October 30, 2020

Re: Sudbury-Hudson Transmission Reliability and Mass Central Rail Trail Project

On behalf of NSTAR Electric Company d/b/a Eversource Energy ("Eversource"), VHB is providing supplemental information in response to the requests for additional information dated September 24, 2020, and October 15, 2020, from the Sudbury Historical Commission. Requests made in the letters are set in bold and italic below, and responses are provided in plain text.

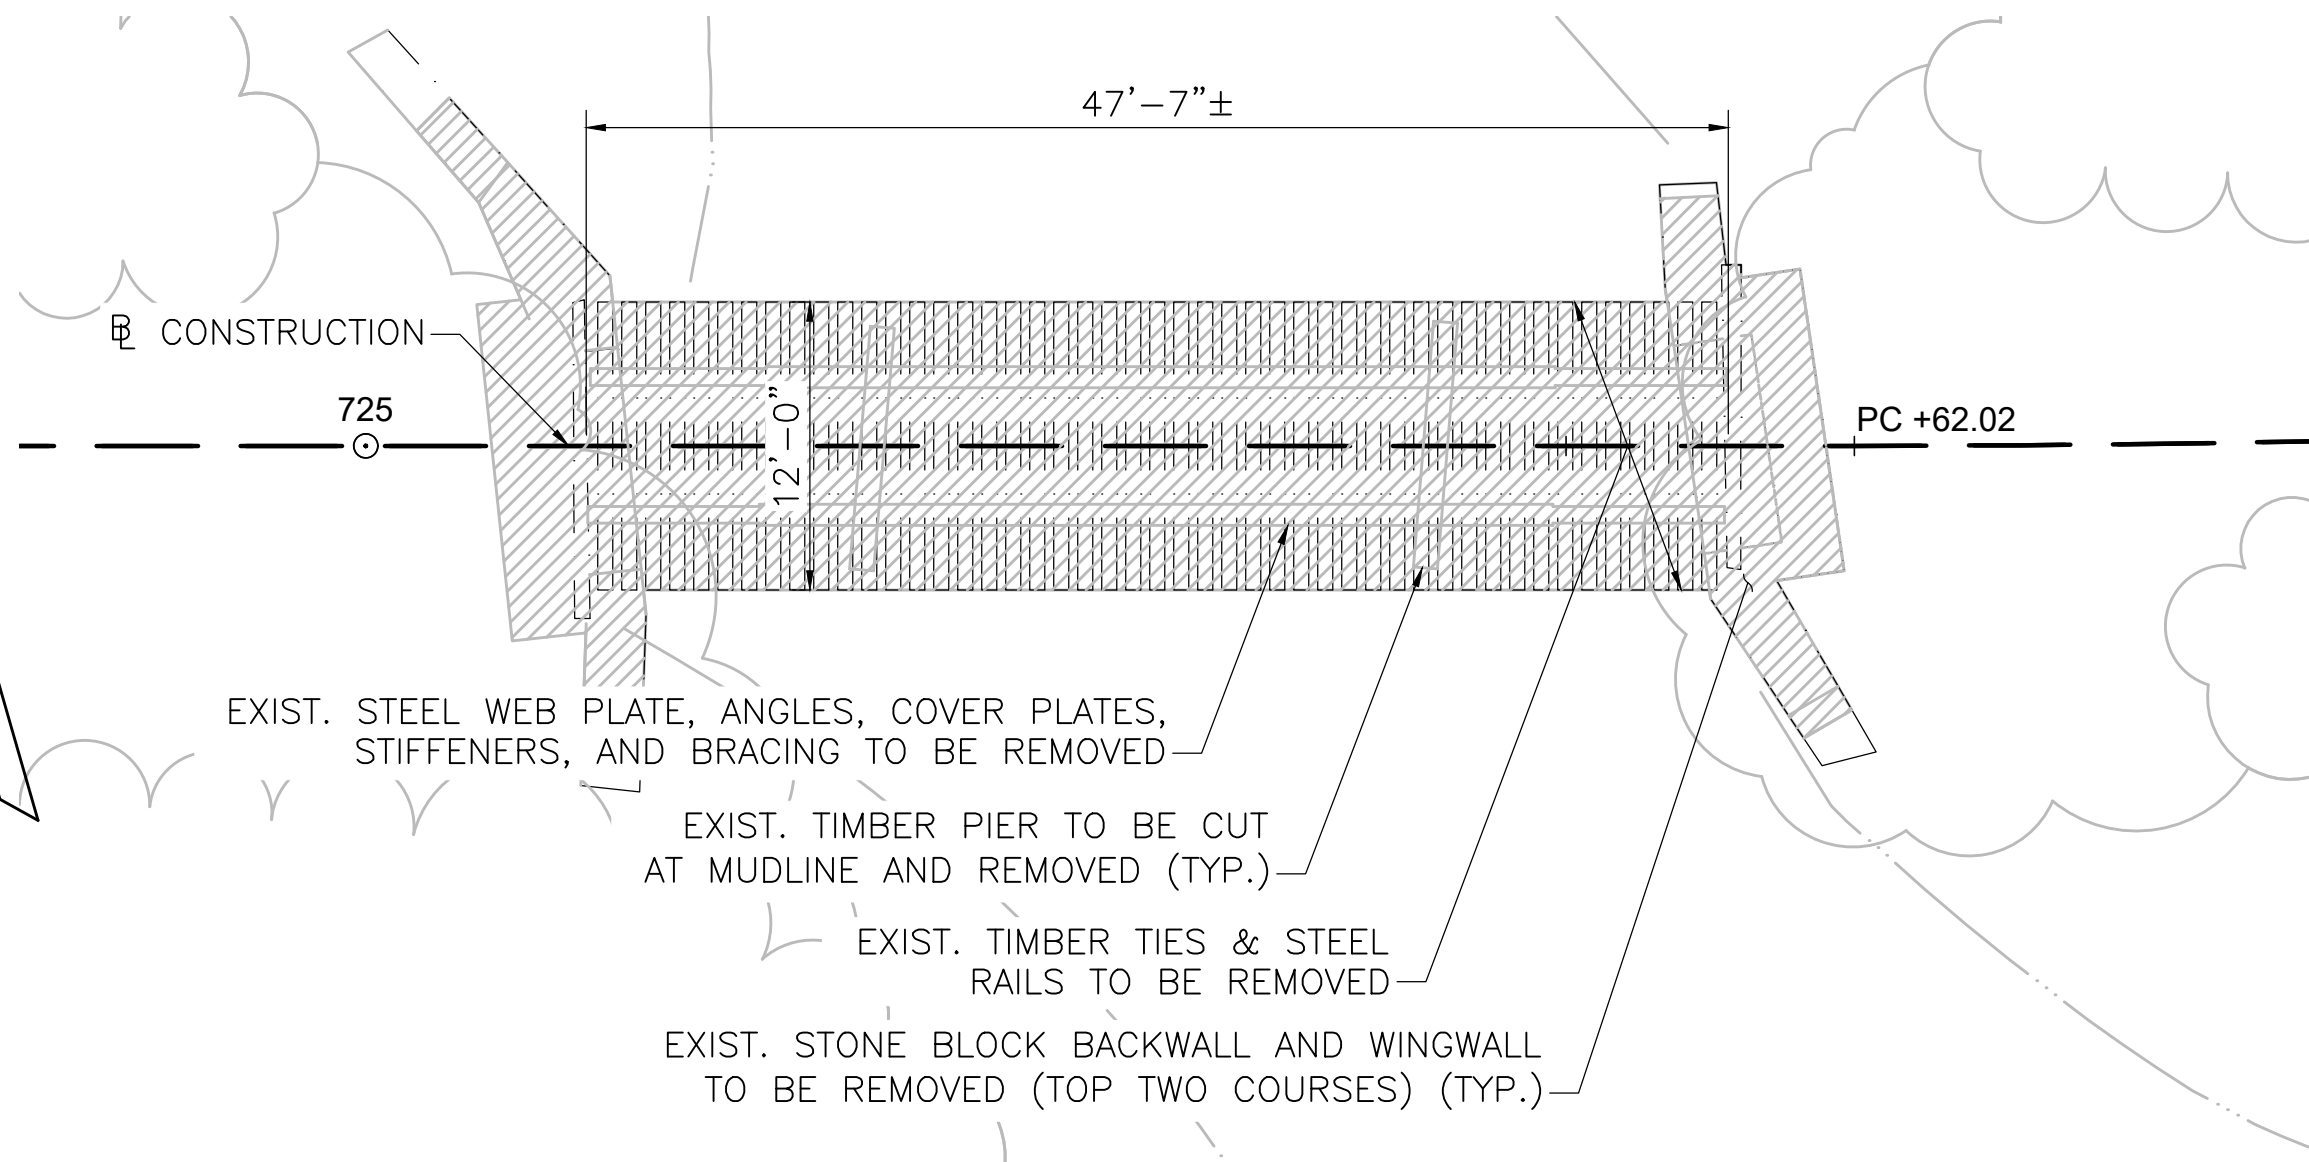
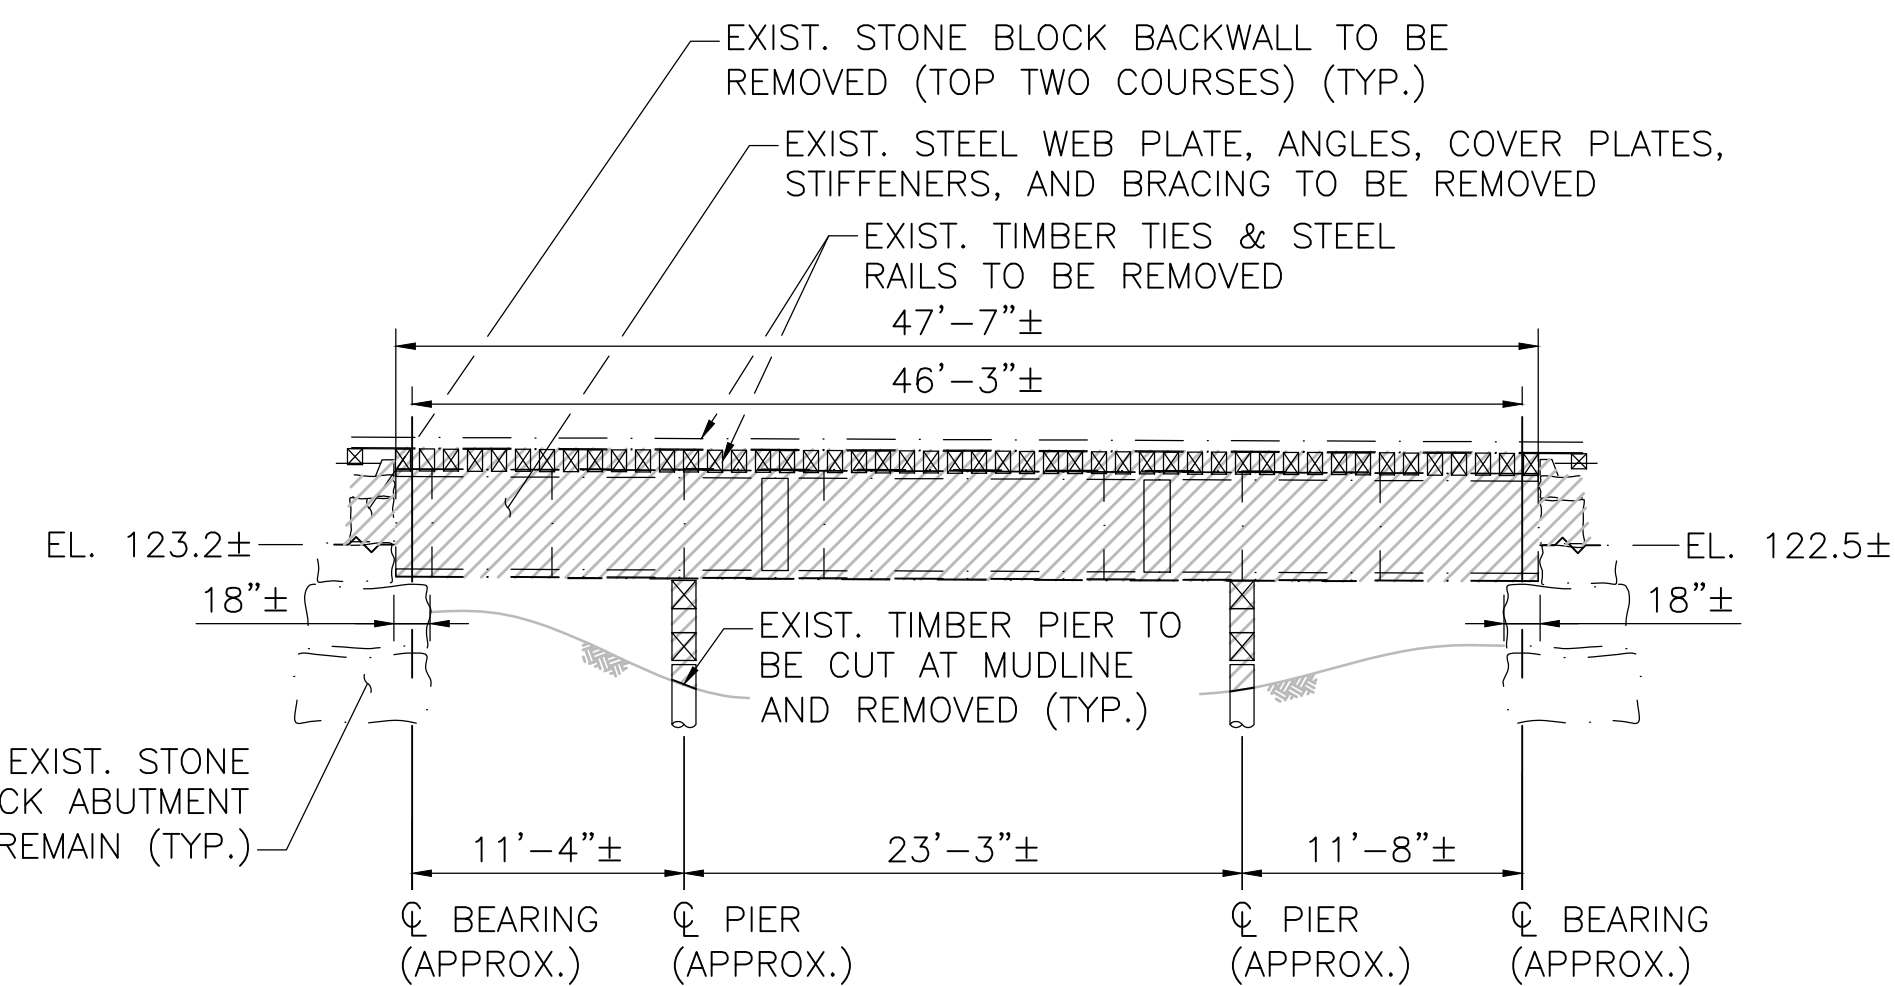
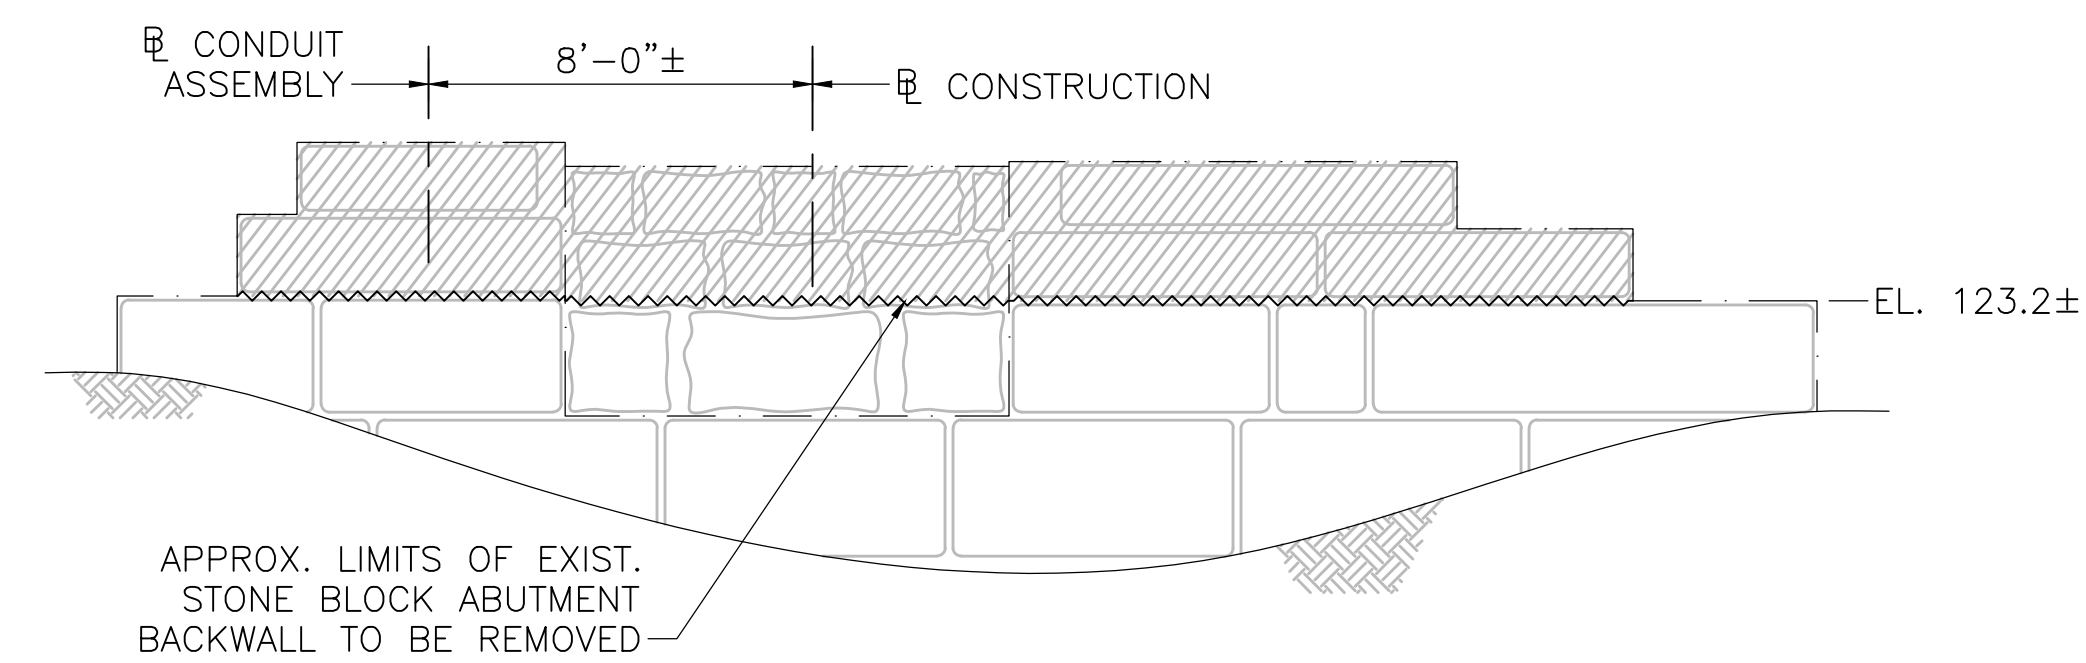
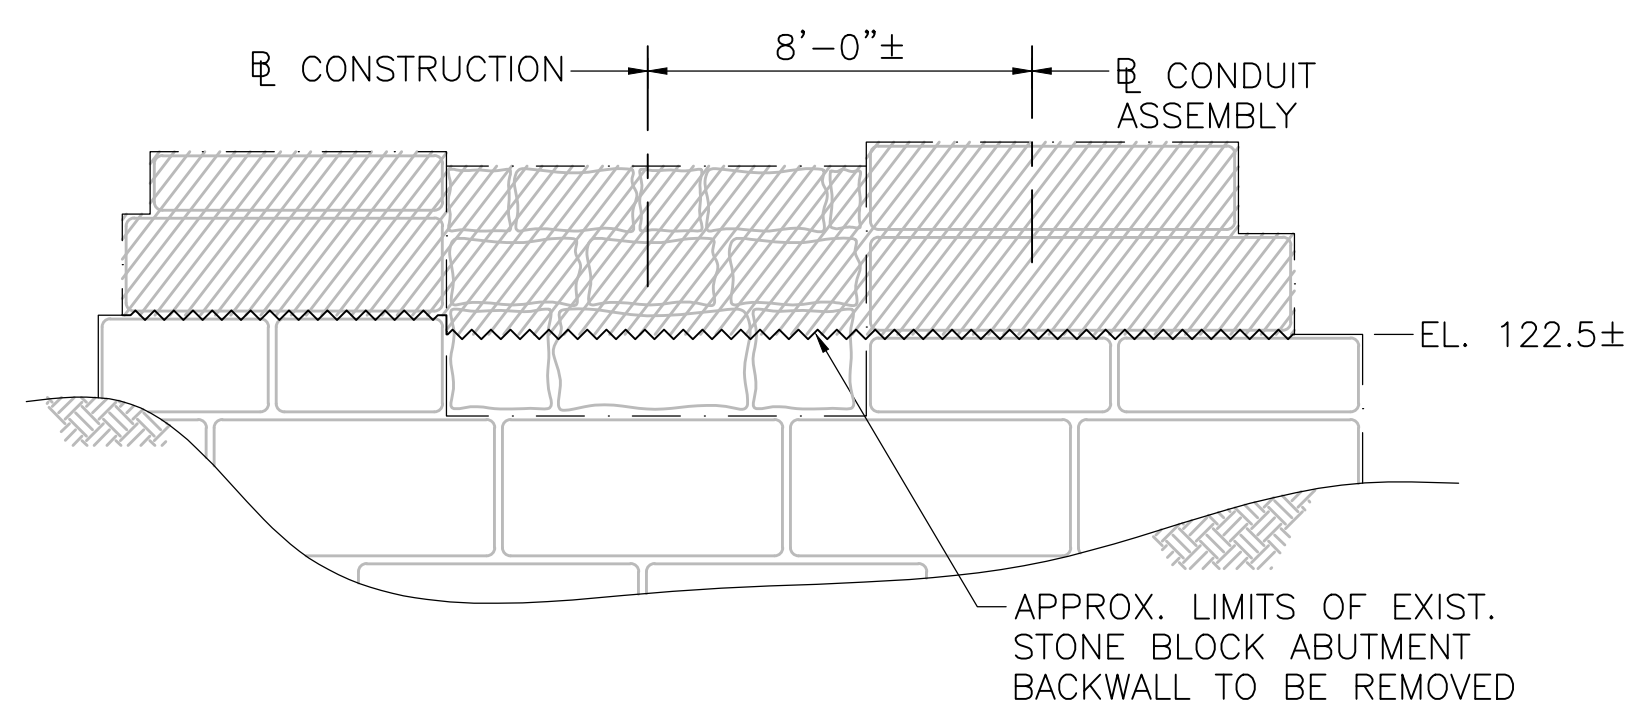
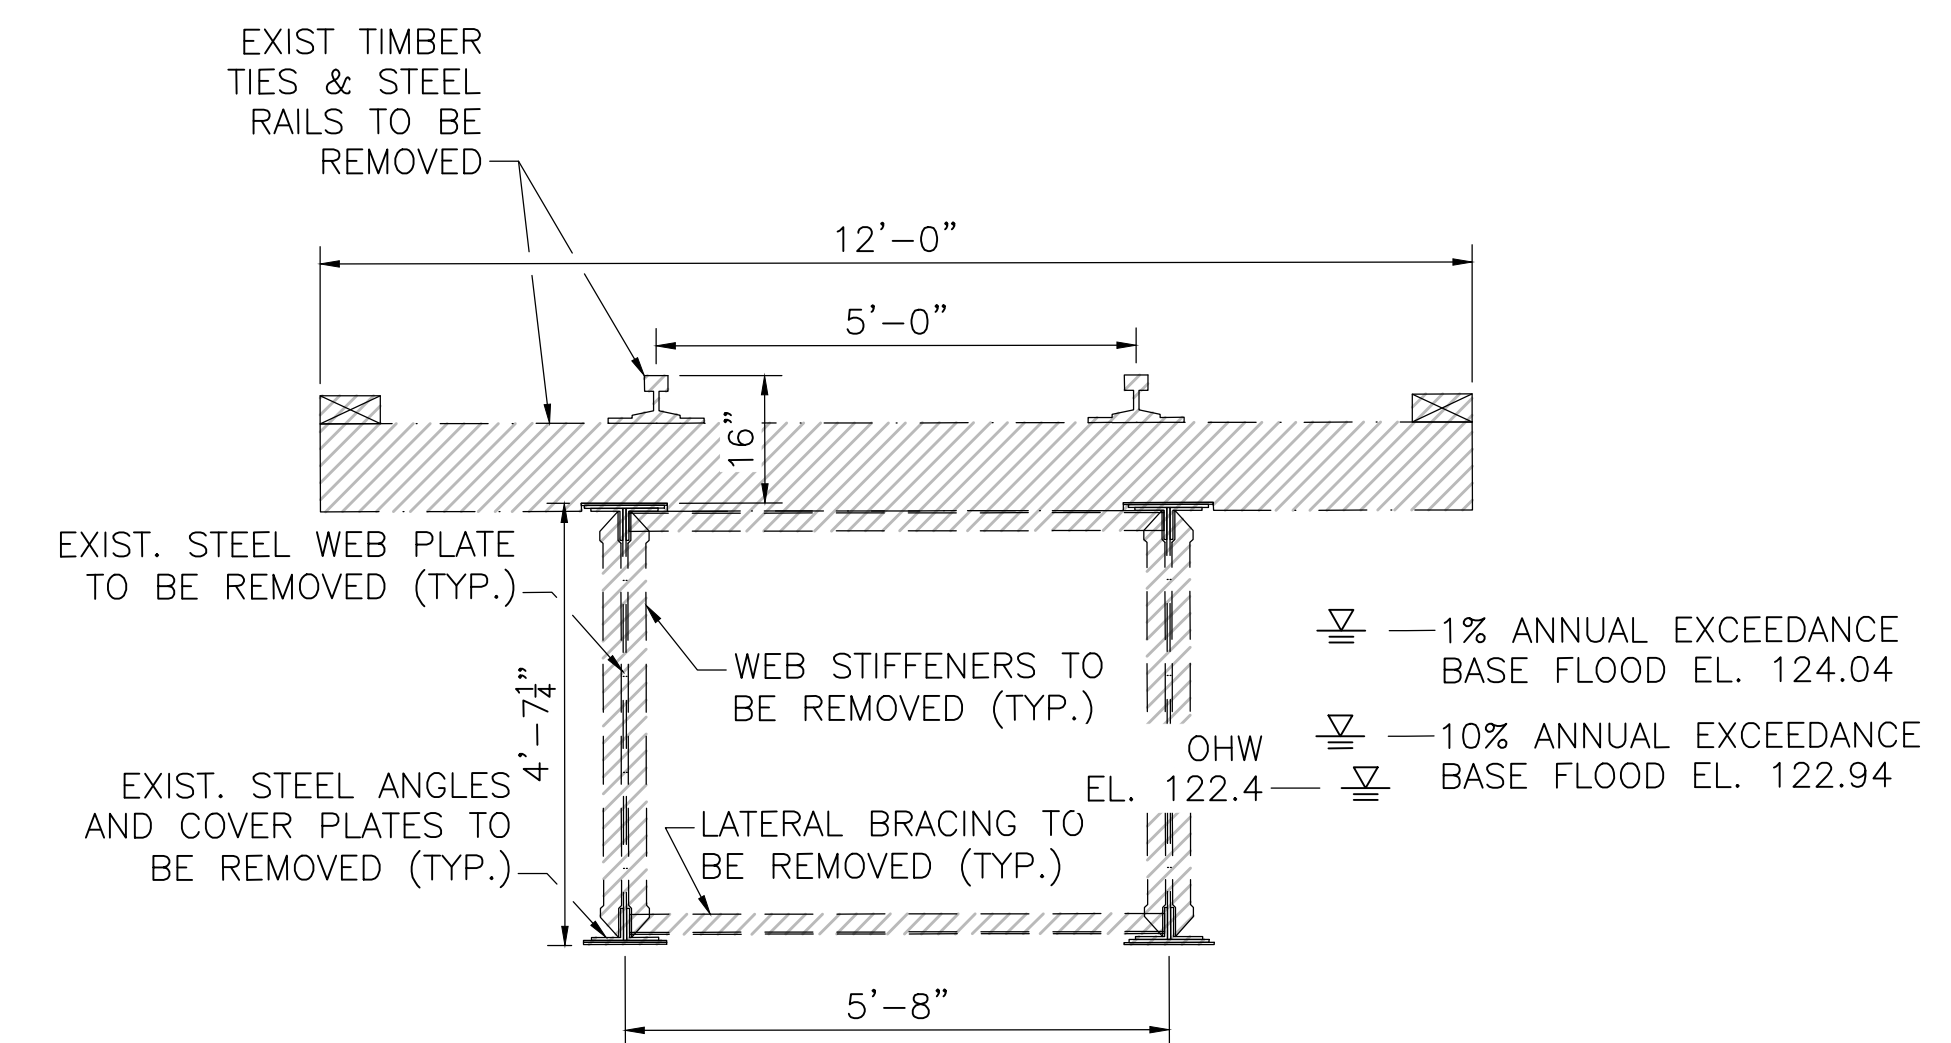
Clarify which granite embankment abutment blocks will be removed on Hop Brook Bridge #127 and #128 on a photo rendering with descriptions.

As shown on the previously provided photo renderings, at Bridge 127 the top two courses of the existing stone block backwall will be removed, and at Bridge 128 approximately 18" of the existing stone block backwall will be partially removed. In addition, the areas to be removed are shown on the attached plan sheets for both bridges.

Existing stone block backwall to
be removed (top 2 courses)
